**VALUE ENGINEERING SUMMARY  
OF THE  
INTERSTATE WIDENING PROJECTS  
PAVEMENT DESIGNS  
FRANKFORT, KENTUCKY**

**MARCH 23-27, 1998**

**Prepared by:  
Ventry Engineering**

**Kentucky Transportation Cabinet**

**TYPICAL ASPHALT OVERLAY DIMENSIONS**  
**DETAIL '1A''**

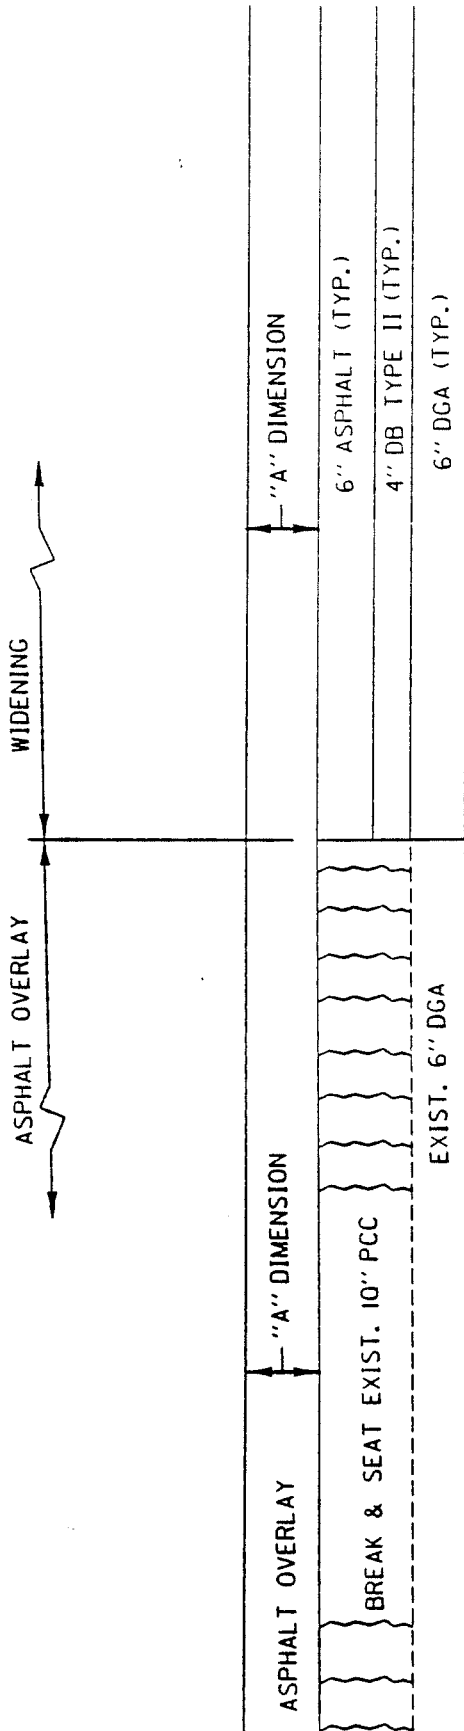
Note: Check Table thickness, original design. Table values appear high.

VE Alternative -  
 widening  
 'A"  
 10" TYPE II DB  
 6" DGA  
 Suggestion for High SIDE of SE. Substitute DGA FOR DB.

Note: Check ORIGINAL table Overlay thickness. **XX SEE NEXT SHEET FOR VE Alternative**  
 Appears too low. Appears that surface max (1 1/2") was not taken into consideration.

**TYPICAL ASPHALT OVERLAY DIMENSIONS**  
**DETAIL "2A"**

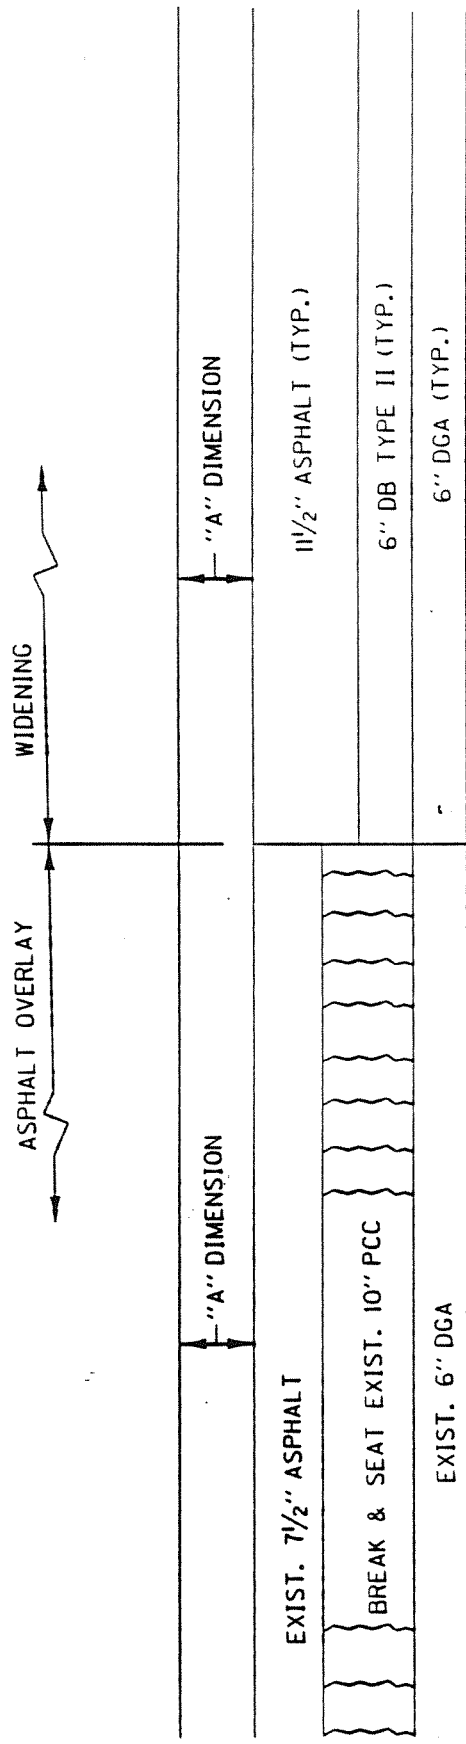
Detail 'ZA' Value Engineering Alternative

CBR	2	4	7	11
ESAL'S	"A" DIMENSIONS			
30X10 <sup>6</sup>	7.5	6.0	4.5	3.0*
50X10 <sup>6</sup>	9.0	7.5	5.5	4.5
70X10 <sup>6</sup>	10.0	8.0	6.5	5.0

\* 4.5 unless a binder course is added.

AX SEE Next sheet for VE Alternative.

**TYPICAL ASPHALT OVERLAY DIMENSIONS**  
**DETAIL '3A'**

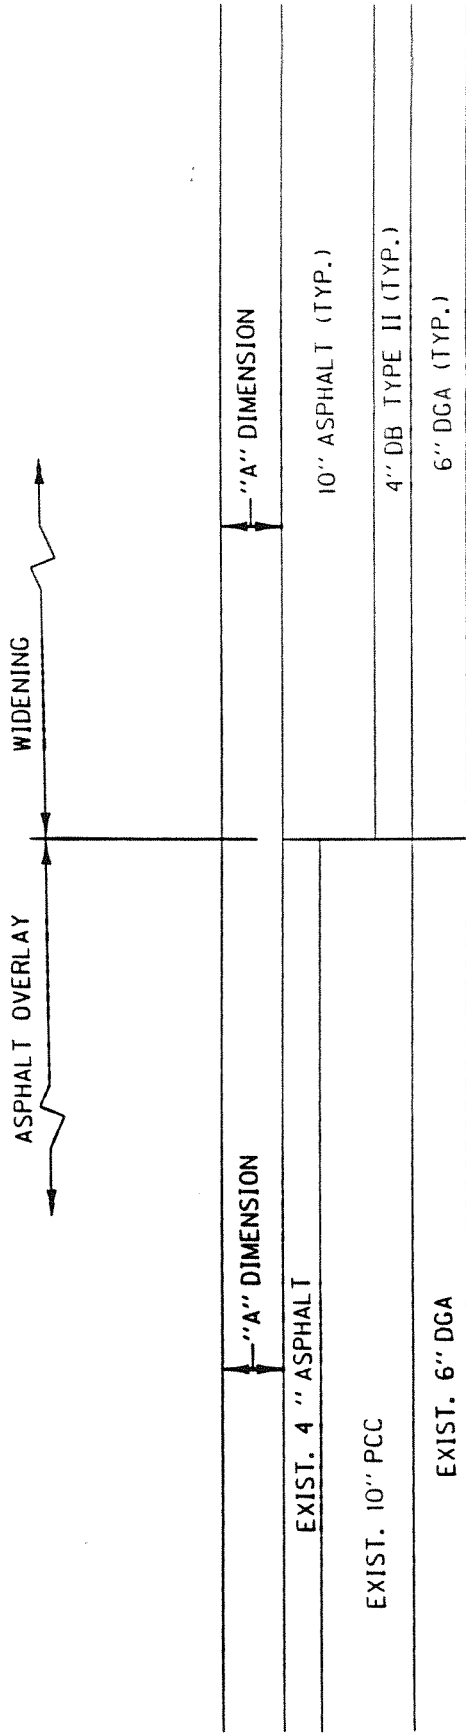
Detail "3A" Value Engineering Alternative

- A"
- 3 1/2" CK MIX (BASE)
- 2" Crushed Stone Base (locker)
- 9" Type I Drainage Base
- 6" DGA

SUGGESTION FOR High Side of SE - widening  
Substitute DGA FOR DB and CCB (Crushed  
stone base)

Note: Very similar to  
table for Detail 1A  
VE Alt.

**DETAIL '1B'**

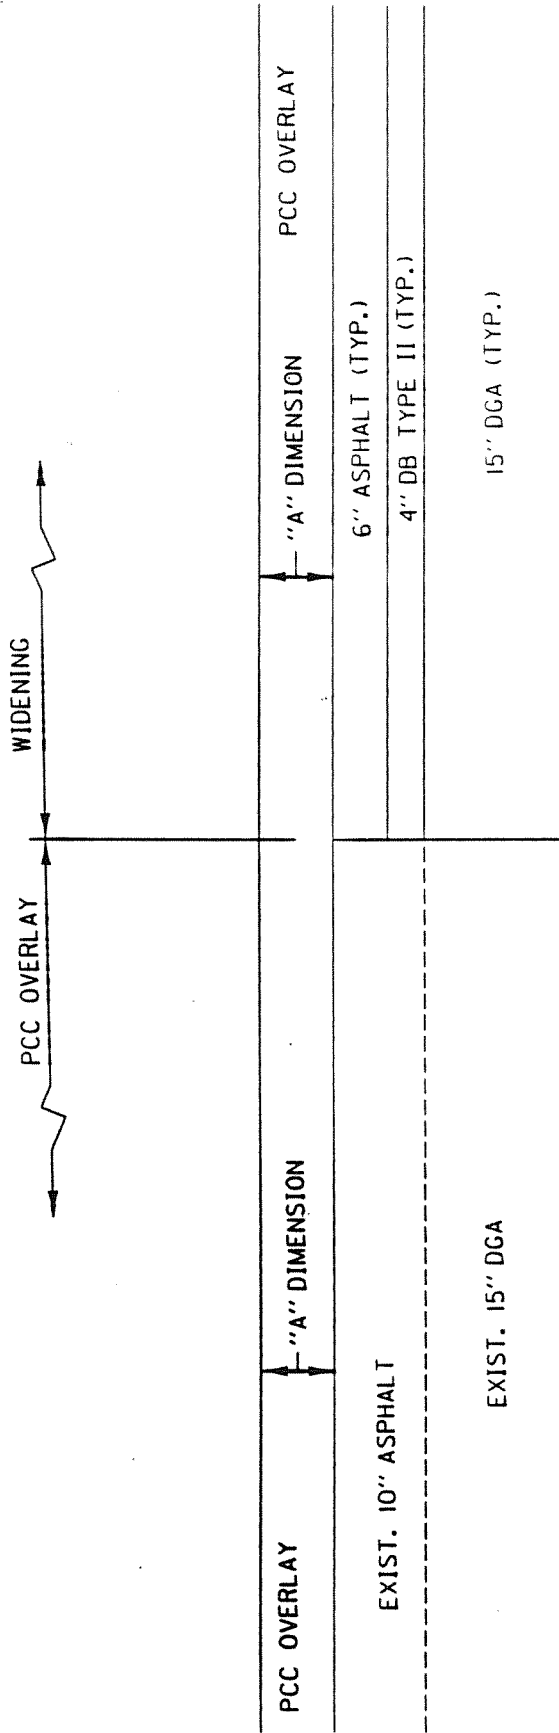
*High side of SE -  
USE DGA (16")  
1 1/2" Bond Breaker  
"A"*

overlay - no change

DETAIL "4B"

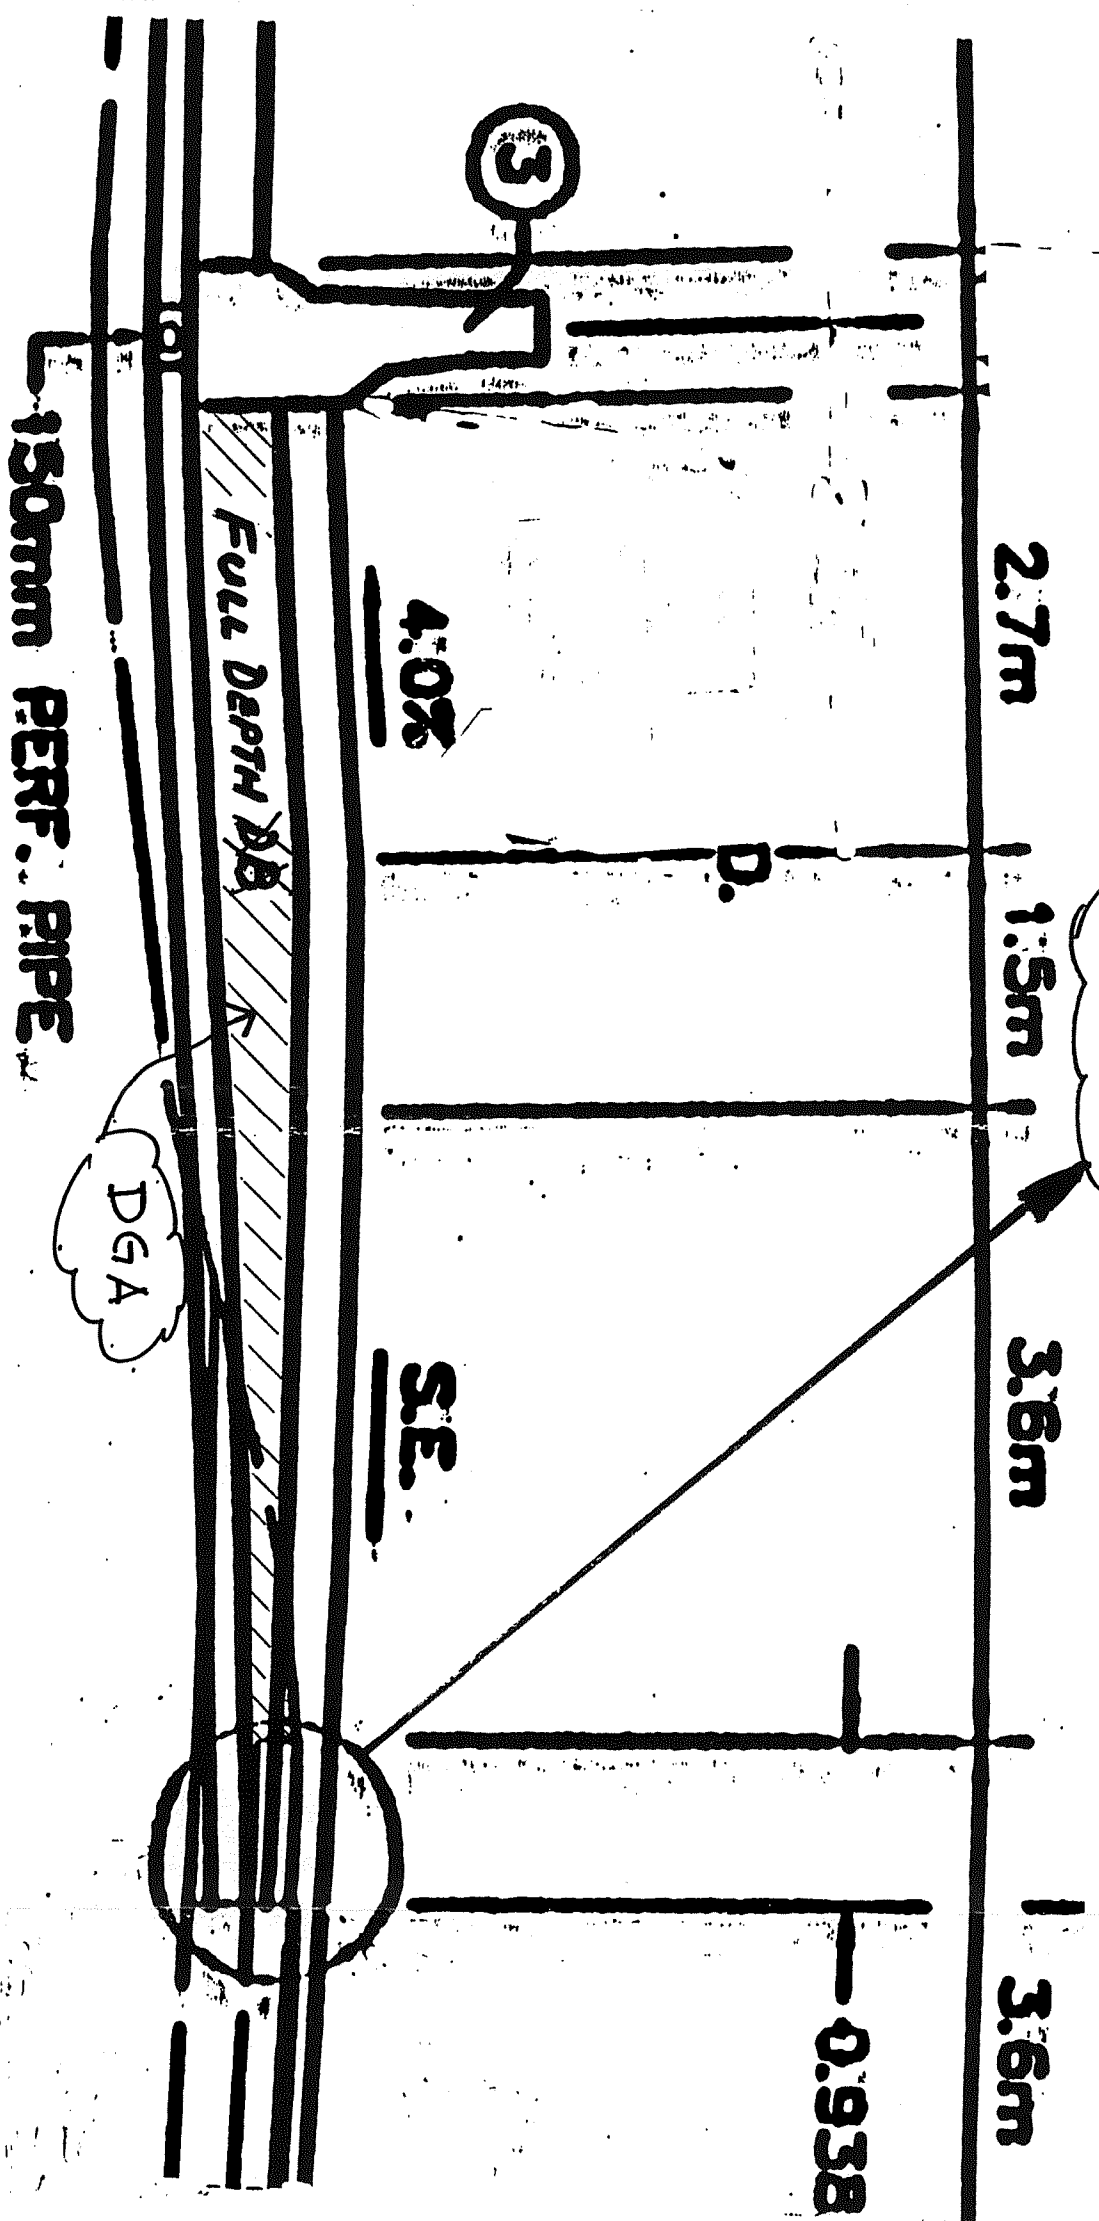
- "A"
- 4" CI
- 16" DGA

\* Match Existing DGA
